Lead Local Flood Authority

Date 06/11/2025

**DC/25/1327 Land East of Mousdell Close Rectory Lane Ashington RH20 3GS
Erection of 74 dwellings with associated access, parking, and landscaping.**

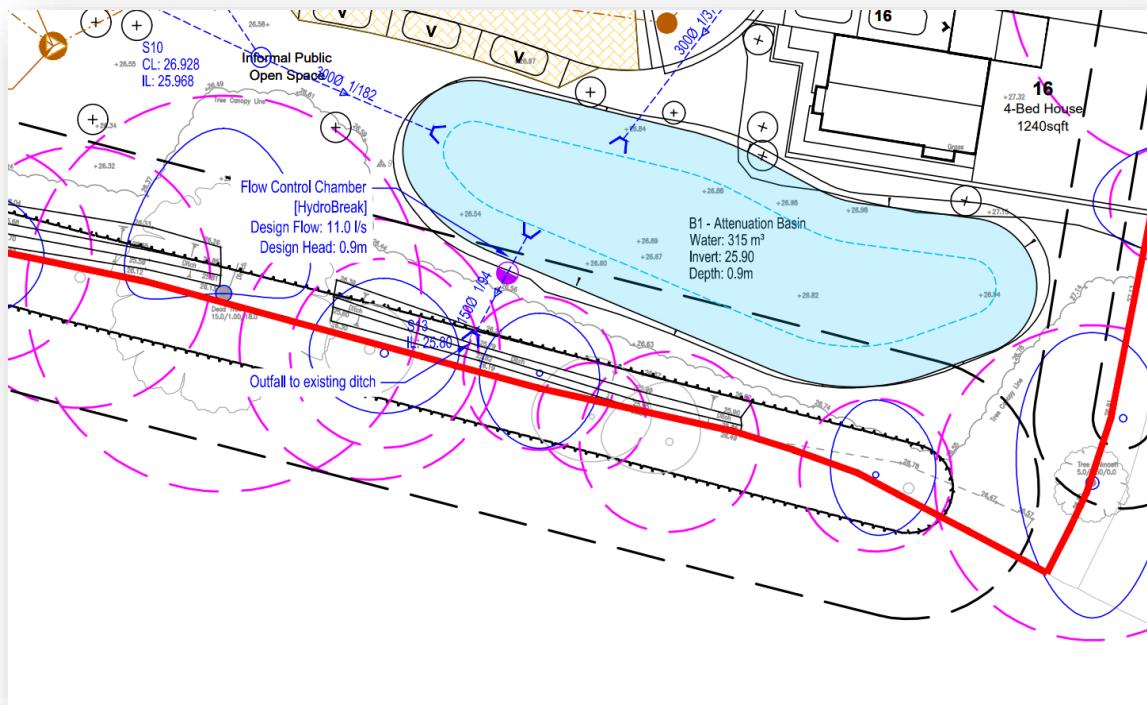
c) *Further information about the acceptability of the proposed discharge to the receiving watercourse needs to be submitted.* The new technical note states: “*The drainage ditch shown in the topographic survey is not that which is intended for the surface water discharge (hence why we are not addressing the comment that there appears to be a blockage in this ditch). The drainage ditch that is on the topographic survey is a drainage grip dug by the farmer to assist with field drainage. The actual discharge point will be the watercourse that is immediately to the south of the drainage grip on the boundary of the site (and which the landowner has riparian rights to).*” This statement appears to directly contradict the Drainage Strategy Plan (Drawing ref: 2504072-0501 P03) that was re-submitted as appendix K of the technical note. In that drawing the outfall from the proposed SuDS scheme is shown to discharge to a non-contiguous ditch within the site boundary and north of the tree line, which would appear to be the drainage grip mentioned above. (See excerpt below from the drainage strategy plan).

As discussed in my initial comments: The surface water drainage layout plan provides insufficient information about the receiving watercourse's: location, nature, condition, hard bed levels, and connectivity with the wider network of watercourses. To remove our objection, we need to be satisfied that there is a

viable destination for the site's discharge. Therefore, if the above statement from the technical note is correct (thus meaning the drainage strategy plan is erroneous), can the applicant please submit an amended drainage plan, detailing: The proposed discharge invert level, the existing silt levels, and the hard bed levels in the receiving watercourse. Additionally, two images of what I assume is the watercourse in question have been uploaded to the portal (dated 23rd October), these two images also raise concerns about the condition of the watercourse, as it appears to be severely obstructed with silt and debris). Can the applicant therefore please add a note to the amended drainage strategy plan confirming that routine maintenance (in the form of removal of debris, de-siltation and re-grading) necessary to ensure the receiving watercourse is in a suitable condition to receive the discharge from the site, will be undertaken.
